REPORT AMENDED BY STAFF 8-8-91
CITY PLANNING COMMISSION
 1231 "I" STREET, SUITE 200, SACRAMENTO, CA 95814

- APPLICATION:**
- A. Negative Declaration
 - B. Plan Review to construct a 110,400 square foot warehouse building on 8.8+ vacant acres in the Light Industrial- Review (M-1-R) zone

LOCATION: Northeast corner of Raley Boulevard and Santa Ana Avenue

EXHIBIT - B

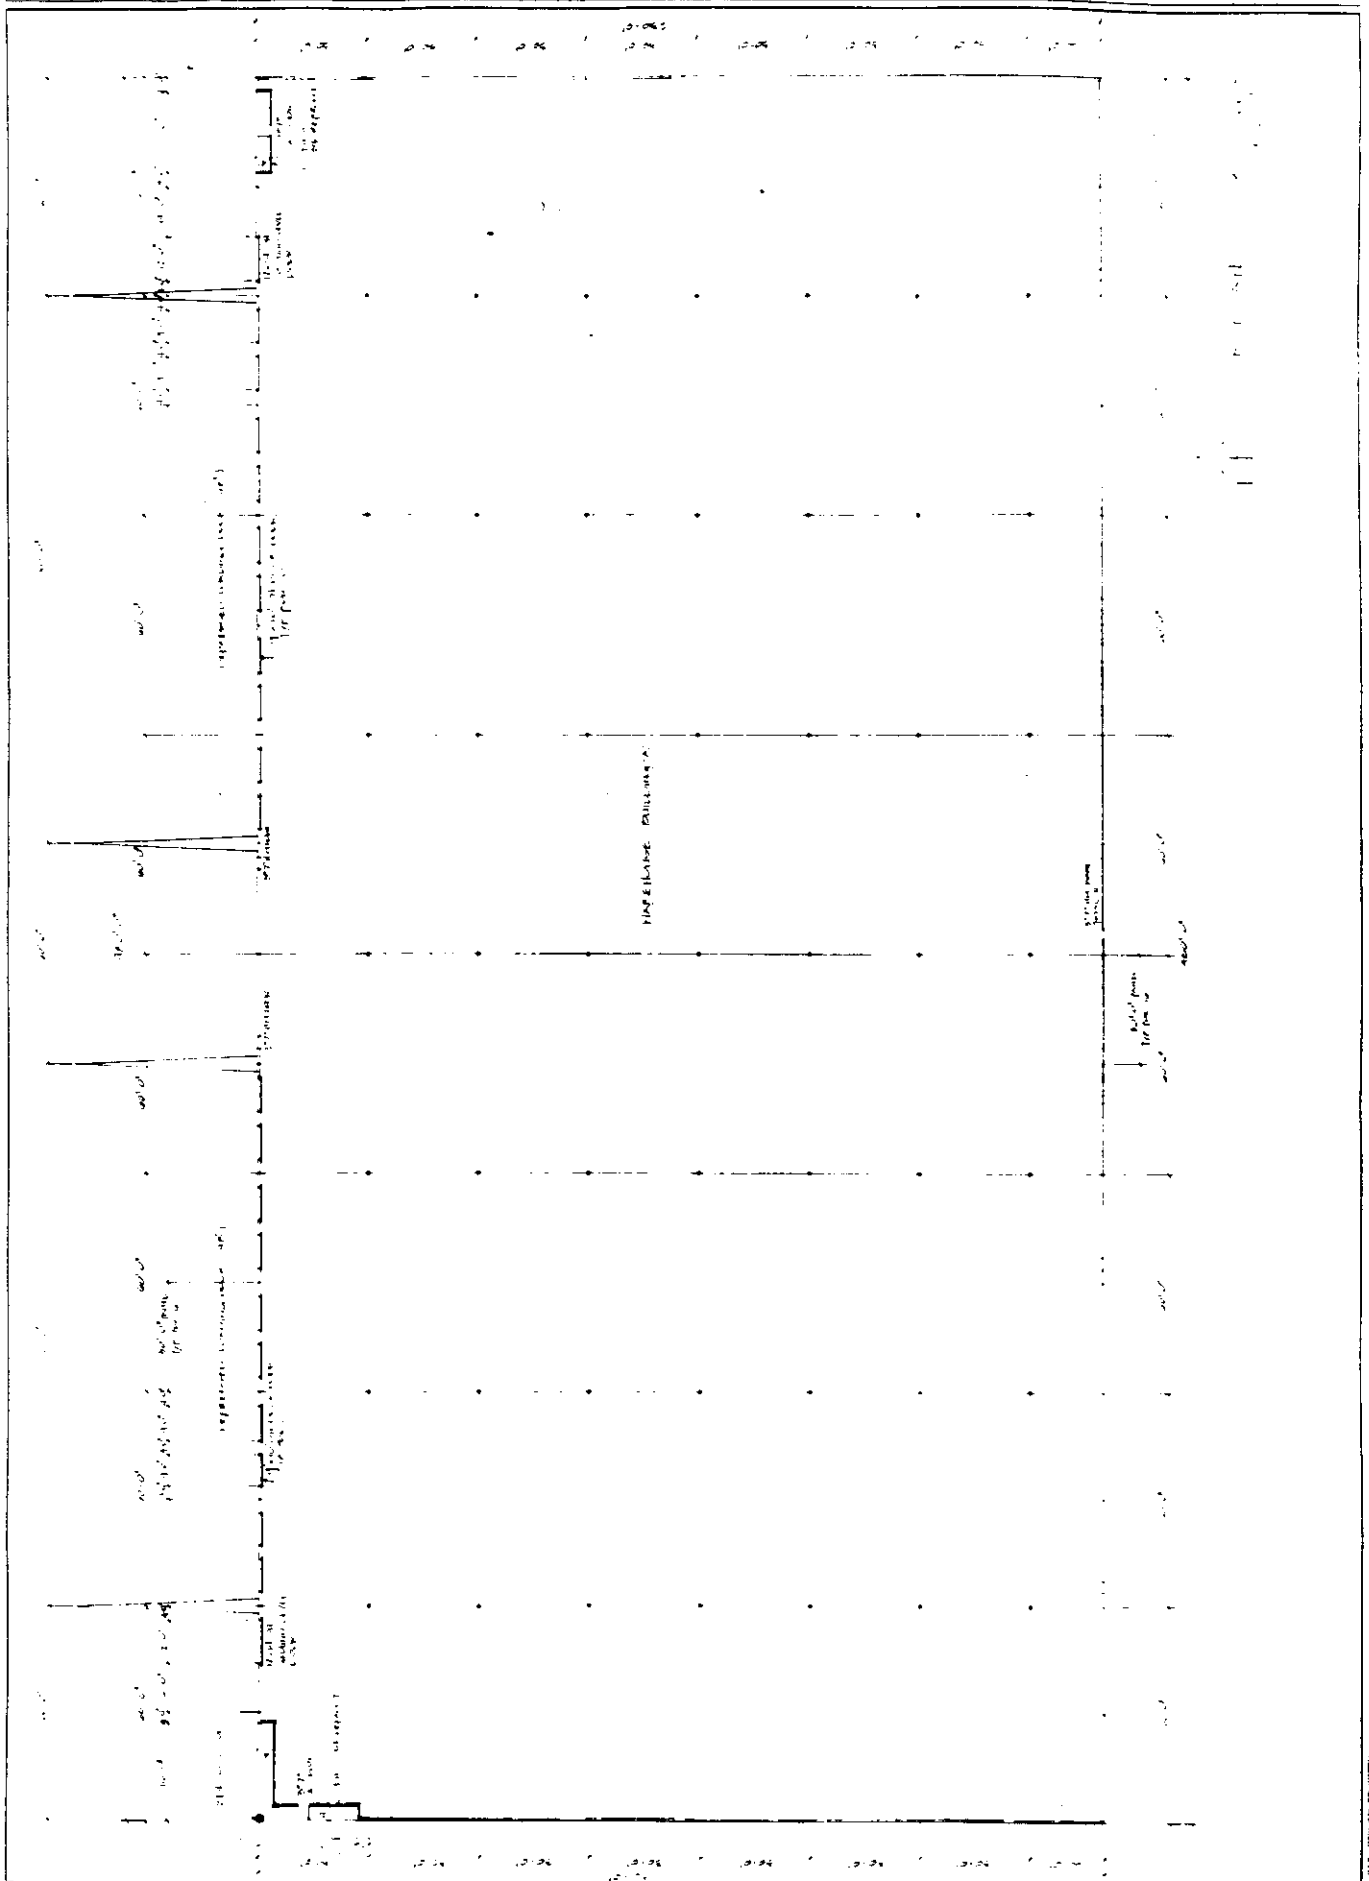
According to the Zoning Ordinance, no setbacks are required in the M-1-R zone. The applicant has proposed 25 feet of landscaping along Santa Ana Avenue and 25 feet of landscaping for a portion of Raley Boulevard. Staff suggests the 25 feet of landscaping be provided along the entire Raley Boulevard frontage. The applicant should submit a revised site plan which indicates this 25 feet of landscaping and the relocation of the required parking. The applicant should also submit a detailed landscape plan for review and approval of the Planning Director prior to the issuance of Building Permits. Staff suggests the 25 foot landscaped areas be landscaped with a combination of turfed undulating berms, shrubs and trees. The site plan also indicates a future development area. This area may not be used for parking or storage of any materials unless it is paved to City standards, and it

should be barricaded with a landscaped planter as indicated on the submitted site plan.

1. Raley Boulevard will be a six lane major street with limited access. No left turn access on to Raley Boulevard from the site. Recommend redesign to provide major access on Santa Ana Avenue; and
2. Comply with the guidelines of the developer TSM ordinance as a "major project".

8. The applicant shall submit a revised site plan which indicates a 25 foot landscape setback along the entire Raley Boulevard frontage and the relocation of the required parking. The revised plan shall be submitted to the Planning Director for review and approval prior to the issuance of Building Permits.

10. The applicant shall provide and maintain landscaping on the five foot strip shown on the site plan between the Phase II warehouse building and the north property line.

11. No parking, driving, or storage shall be allowed on the undeveloped northeast portion of the site. A six inch concrete curb or other suitable barrier shall be provided with the landscaping as shown on the submitted plans to prevent use of the undeveloped portion of the site. The area may be used provided it is paved and landscaped to City standards.
